# INITIAL FIRE SAFETY INSPECTION REPORT

## ASWAD COMPOSITE MILLS LTD. ( U-2) (EXTENSION)

**RSC ID: 25868**

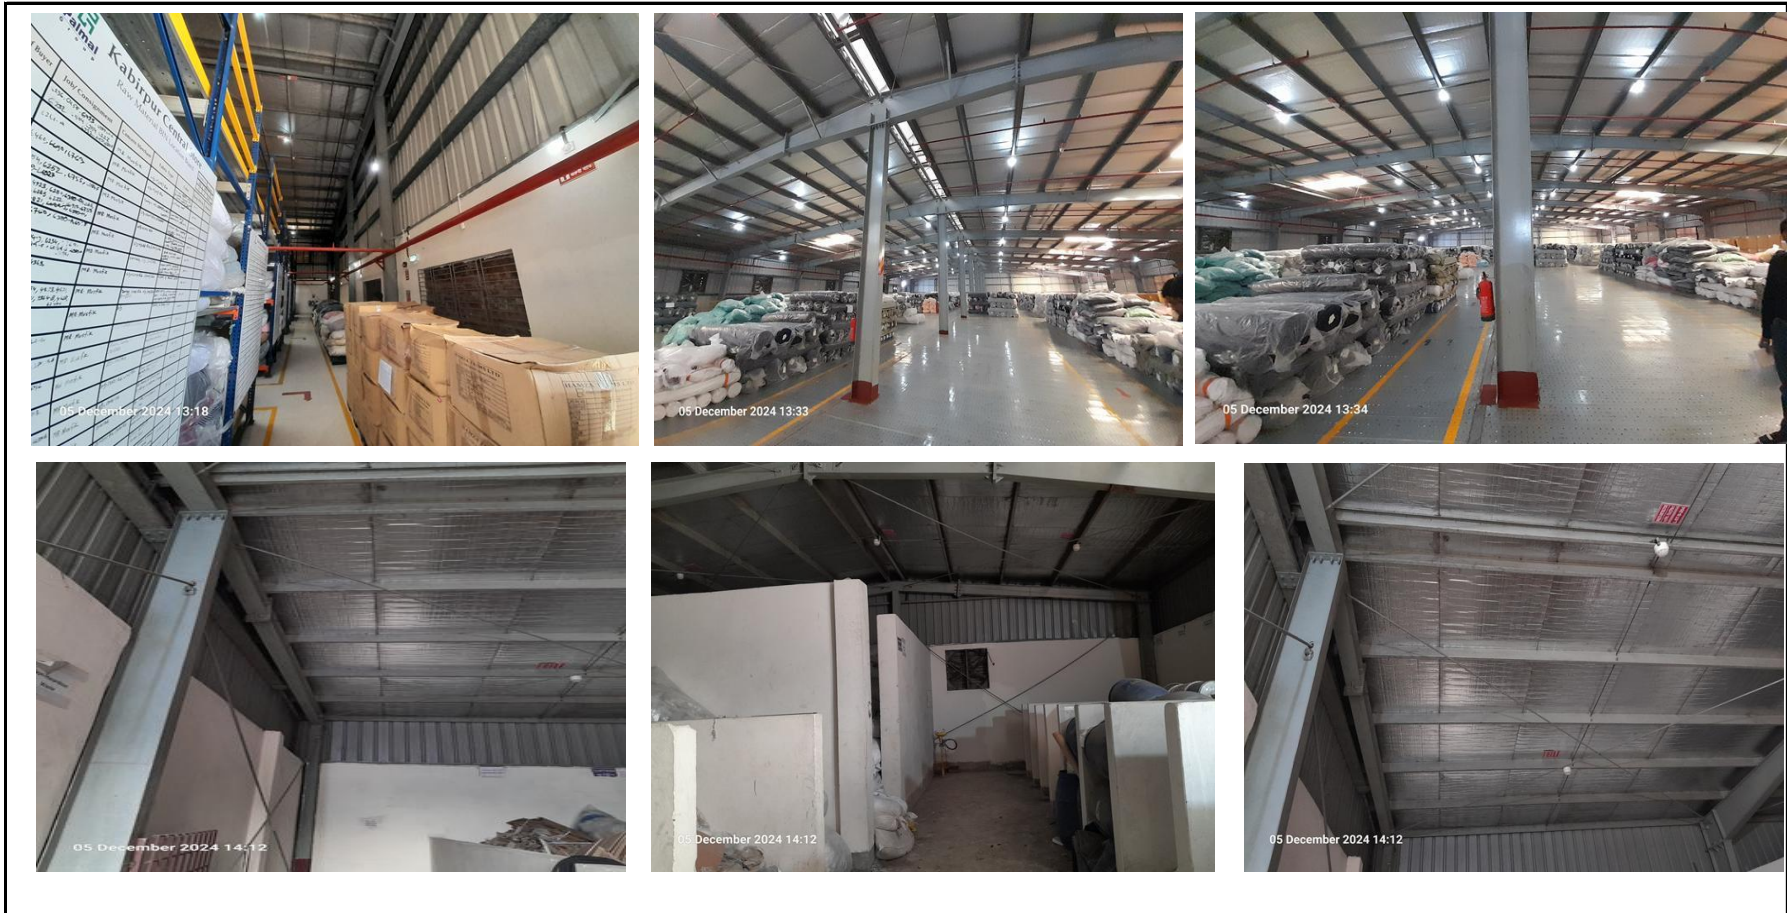
F-2	Fire Rated Construction	<p><b>Single Storied Pre-fab Fabric Store Shed (G) with non-rated intermediate level:</b> The interior exit stair discharges inside the storage area on ground floor of fabric store shed.</p>	<p>Provide 2-hr fire-rated exit passageway leading directly outside.</p> <ul style="list-style-type: none"> <li>- Modify stair to discharge directly outside.</li> <li>- Provide 2-hr fire-rated exit passageway leading directly outside (vestibules to separate any storage areas).</li> </ul>	Within 3 months

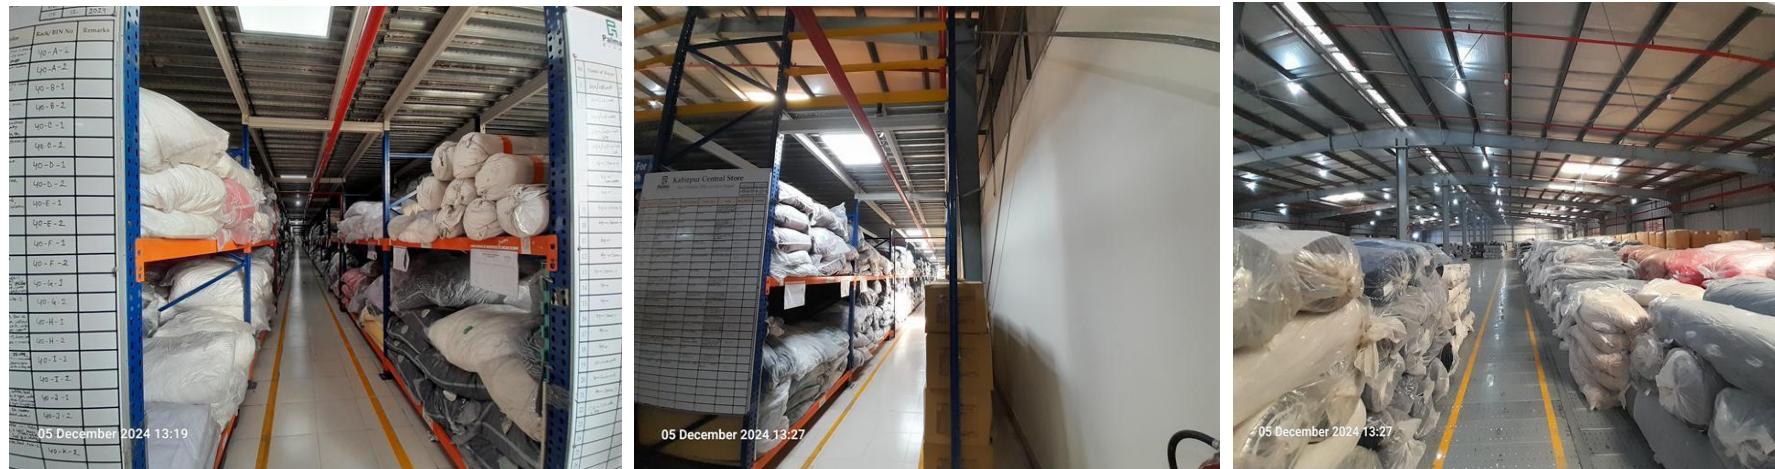
F-4	Fire Rated Construction	<p><b>Single Storied Pre-fab Fabric Store Shed (G) with non-rated intermediate level:</b>          Mezzanine floor area was found more that 33% of main floor and not separate with the ground floor of fabric store shed. Note: Reportedly main floor areas is 2025.092937 sqm and 1st floor level area is 19700 sqm.</p>	<p>The mezzanine floor at the lowest level shall be designated as main floor and each Intermediate floor is limited to an area which is not more than one third of the main floor under one roof or one ceiling.</p> <p>Separate each floors by fire rated construction as per Table 3.3.1 (a), 3.3.1 (b) and Table 3.2.1 Part-III of BNBC-2020.</p>	Within 6 months
-----	-------------------------	--	--	-----------------

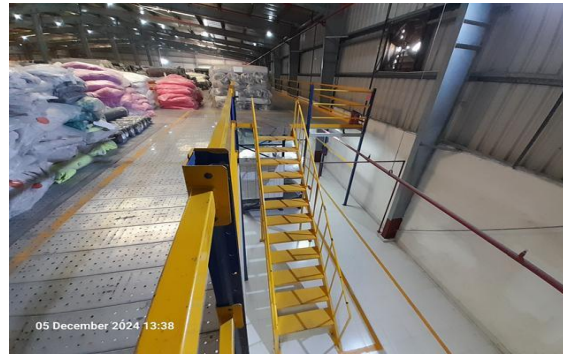
F-5	Means of egress	<p><b>Single Storied Pre-fab Fabric Store Shed (G) with non-rated intermediate level:</b>          Travel distance of egress paths exceeds the allowable limit on the ground and 1st floor level of fabric shed.</p>	<p>Occupant load and components of exits shall be arranged in such a manner that the travel path from any point in the area served shall not be exceeded (38 meter for non-sprinklered and 45 meter sprinklered building) as listed in the Table 4.3.8 of BNBC 2020.</p>	Within 3 months
-----	-----------------	--	--	-----------------

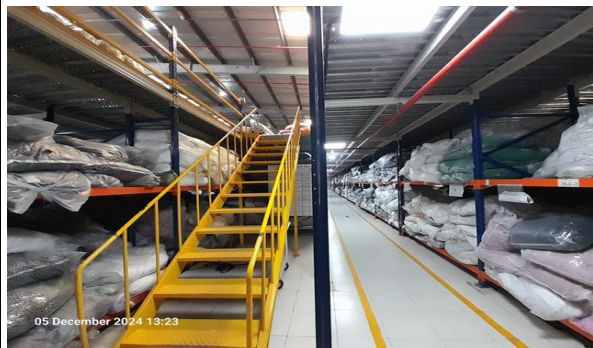
F-7	Means of egress	Handrail height was found less than 0.9 meter from 1st floor level to GF of <b>fabric store shed</b> , and handrail found missing for <b>Rain Water Harvesting Plant stair, and wastage store entrance</b> .	Handrails shall have a minimum height of 0.9 m measured from the nose of stair to the top of the handrail.	Within 3 months
-----	-----------------	--	--	-----------------

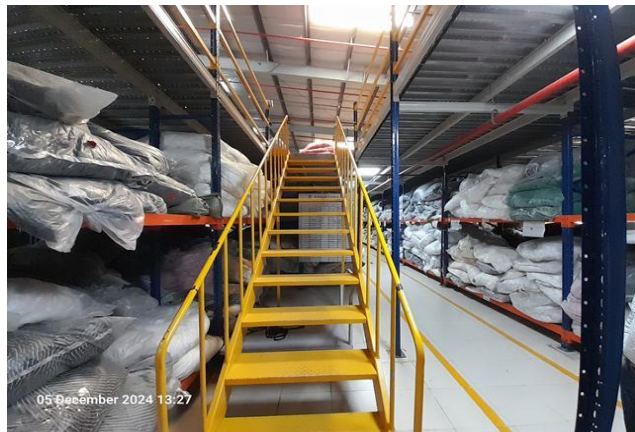
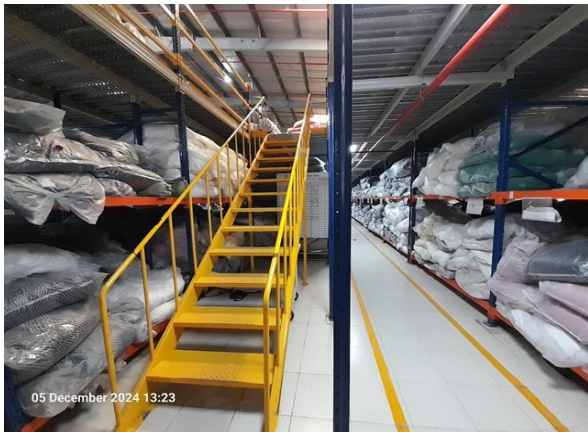
F-8	Means of egress	<p><b>Single Storied Pre-fab Fabric Store Shed (G) with non-rated intermediate level:</b>  Width of exit stairs (1st floor to ground floor stair width-36.5 &amp; 38 inch) are found less than 1.5 m (60 in.).</p>	<p>In new and interim construction stairs shall have a minimum width of 1.5 m (60 in.) for all industrial occupancies.</p>	<p>Within 3 months</p>
-----	-----------------	--	--	------------------------

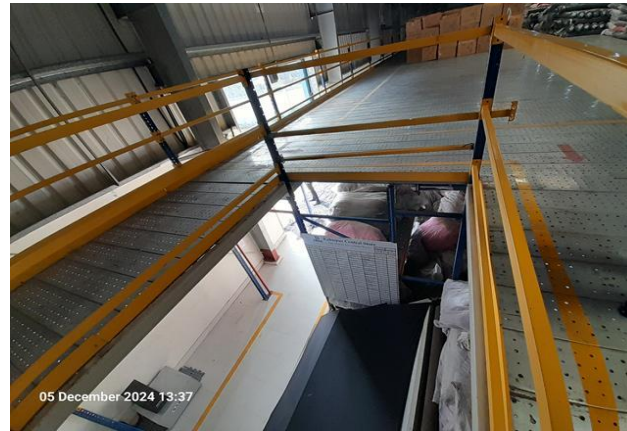
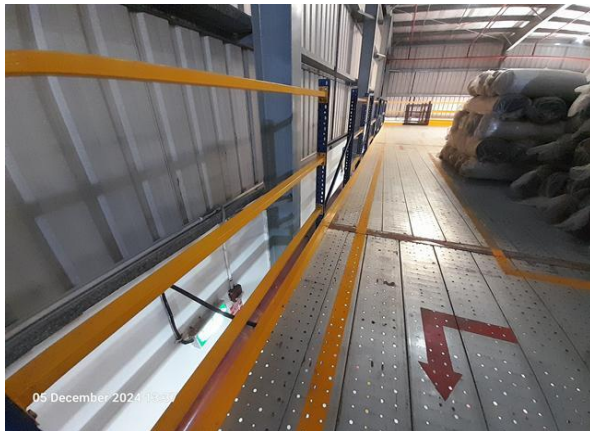
F-9	Means of egress	<p><b>Single Storied Pre-fab Fabric Store Shed (G) with non-rated intermediate level:</b>  Guards on 1st floor level was not provided as per the section 6.12.2 Guards of the RSC Technical Guidelines (Standard).</p>	<p>Guards shall be provided at all open sides of means of egress that exceed 760 mm (30 in.) above the floor or finished ground below:</p> <ul style="list-style-type: none"> <li>-New and interim guards shall have a minimum height of 1067 mm (42 in.).</li> <li>-Open guards shall have intermediate rails or pattern such that a sphere 200 mm (8 in.) in diameter cannot pass through any opening up to a height of 865 mm (34 in.).</li> </ul>	Within 3 months
-----	-----------------	--	---	-----------------

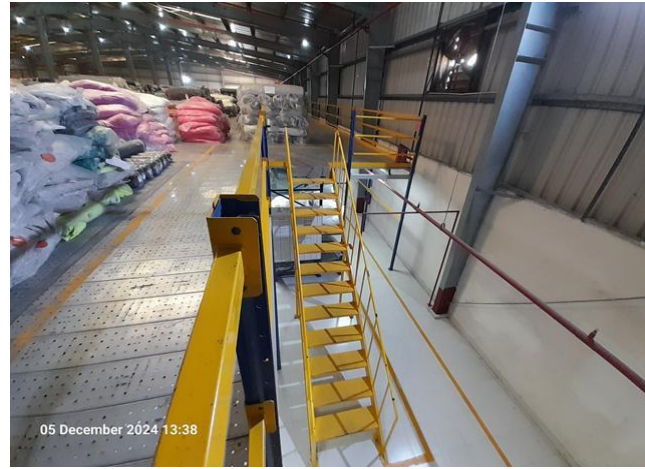
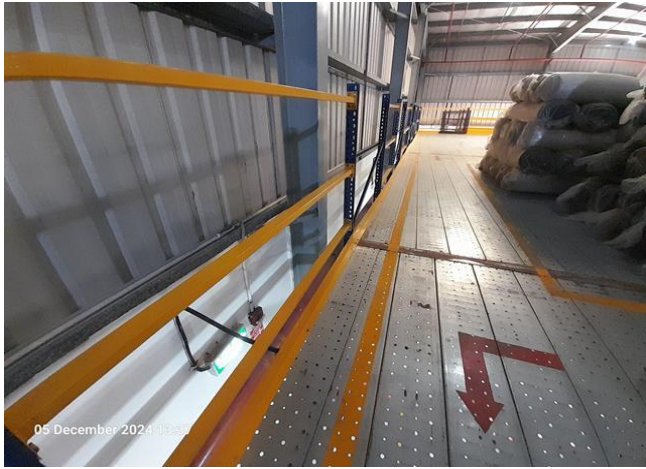
F-10	Means of egress	<p><b>For all structures:</b></p> <p>The building did not have stair designation signs or occupant load signs at the required locations.</p>	Provide stair designation signs and occupant load signs at the required locations.	Within 1 month
F-11	Means of egress	<p><b>Single Storied Pre-fab Fabric Store Shed (G) with non-rated intermediate level:</b></p> <p>Fire evacuation maps are not posted at the entrance to each exit stair.</p>	Fire evacuation maps shall be posted at the entrance to each exit stair.	Within 1 month
F-12	Egress Lighting	<p><b>Single Storied Pre-fab Fabric Store Shed (G) with non-rated intermediate level:</b></p> <p>The directional signs are not provided where there is a change in direction and where the continuation of the egress path is not obvious.</p> <p>Location: On ground and 1st floor level of fabric shed.</p>	Install illuminated directional signs shall be provided where there is a change in the direction for the path of travel and the direction to an exit is not obvious.	Within 1 month

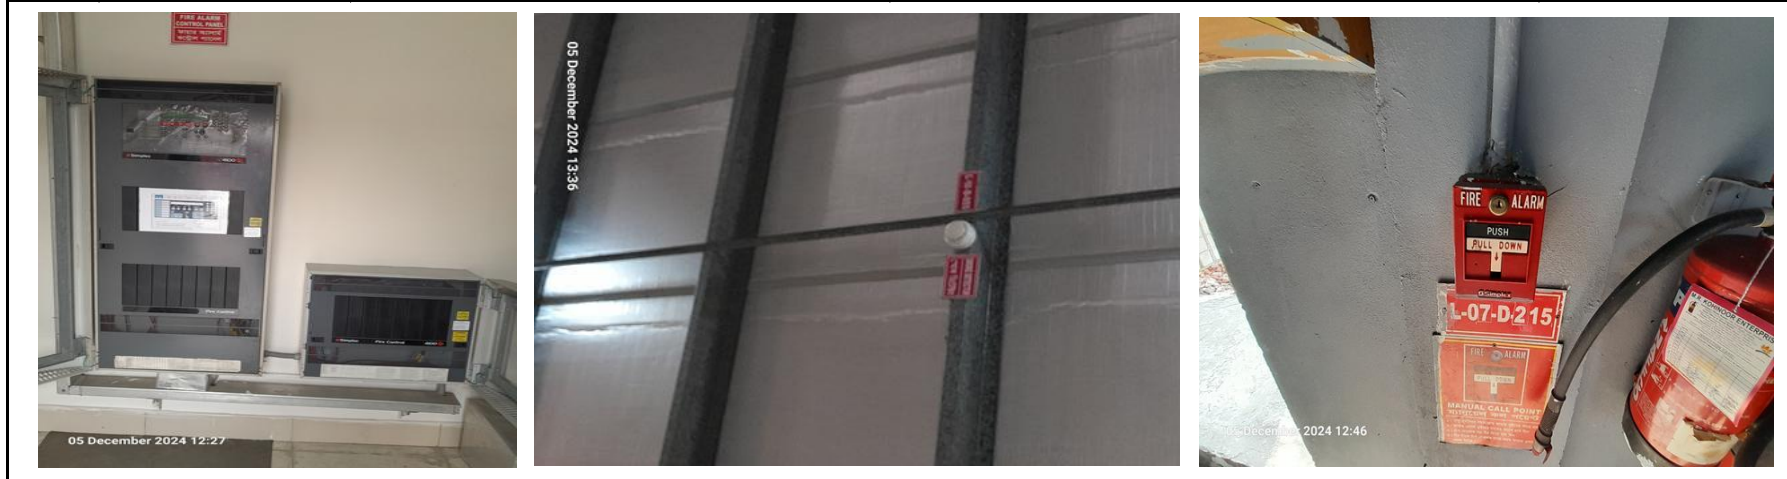
F-15	Fire Alarm & Detection system	<p><b>Single Storied Pre-fab Fabric Store Shed (G) with non-rated intermediate level, Rain Water Harvesting Plant room and containers:</b></p> <p>Automatic fire alarm and detection system installation complete which requires detailed review to confirm compliance with NFPA 72 and The RSC Technical Guidelines (Standard).</p>	<p>Submit the fire alarm system design to the RSC for review. Once the design is reviewed, install and modify the fire detection and alarm system throughout the buildings in accordance with review comment, the RSC Technical Guidelines (Standard) and NFPA 72. After installation the owner shall conduct internal testing and commissioning and then contact the RSC for witness of final acceptance testing. Also inspect, test and maintain the fire alarm system, and keep written records on-site, in accordance with Table-14.3.1 of NFPA 72.</p>	Design Review within 2 months and installation within 4 months
